Re: California Energy Commission (Energy Commission)
Docket No. 09-IEP-1C: Written Workshop Comments of
Southern California Edison Company (SCE) the 2010 –
2020 Peak Demand & Energy Forecasts

Southern California Edison (SCE) appreciates the opportunity to comment on the June 26, 2009 IEPR demand forecast workshop. After the review of the information available, we have identified the following issues:

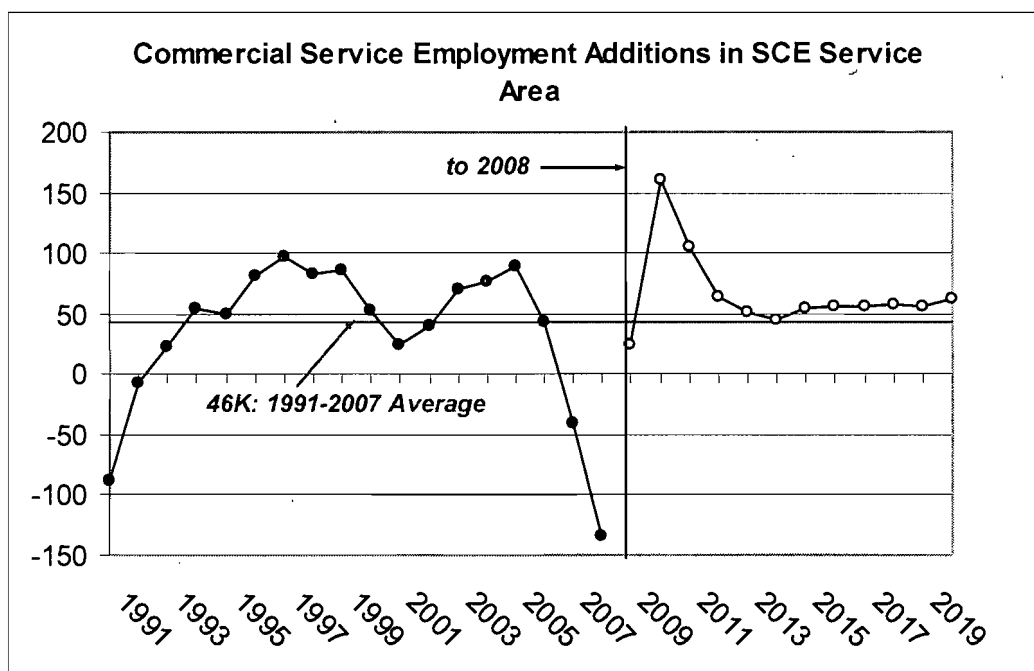
SCE makes its econometric forecast of “energy consumption” rather than sales. Energy consumption is recorded sales plus the committed EE savings plus the estimated self-generation. SCE’s definition of “energy consumption” is similar to Staff’s definition of “unmanaged” consumption, but SCE applies the definition to both history and forecast, and includes the historic savings from committed EE programs. Thus SCE models historic energy consumption, makes a forecast of consumption, and then deducts from this the forecast of self-generation and the forecast of total EE (committed, which decays, plus uncommitted). Thus, in comparing with historical growth rates, comparisons of SCE “unmanaged” must be made against “unmanaged” history. It would be inconsistent to compare recorded or “managed” growth rates or graph recorded energy or peak demand for the historical period of time and then compare this to the forecast level or growth rate of energy and peak demand on an “unmanaged” or total consumption basis. Although Staff does not “add-back” the savings from committed EE programs in its calculation of historic energy consumption, the comparison shown on Table 1 is “apples-to-apples”.

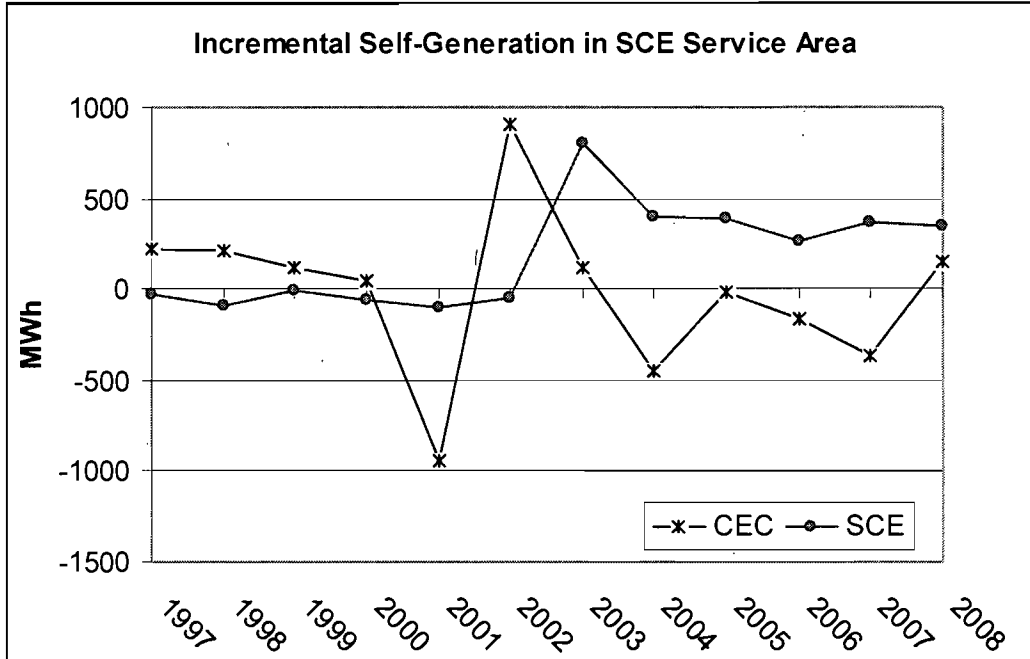
Thus, based on the economic cycles, it would not be unexpected for the forecast period 2010-2020 to show a higher growth rate than 1990-2007. Offsetting this somewhat is the expectation that California employment will not recover to the long-term trend set from 1990-2007—Global Insight currently predicts that there will be a permanent downward adjustment in the long-term economic level compared to the pre-recession average trend, but predict no reduction in the growth rate post recovery (e.g., 2013-2020). This is exemplified in the graph of SCE Service Area Commercial Sector Employment, based on the global Insight economic forecast of April, 2009.
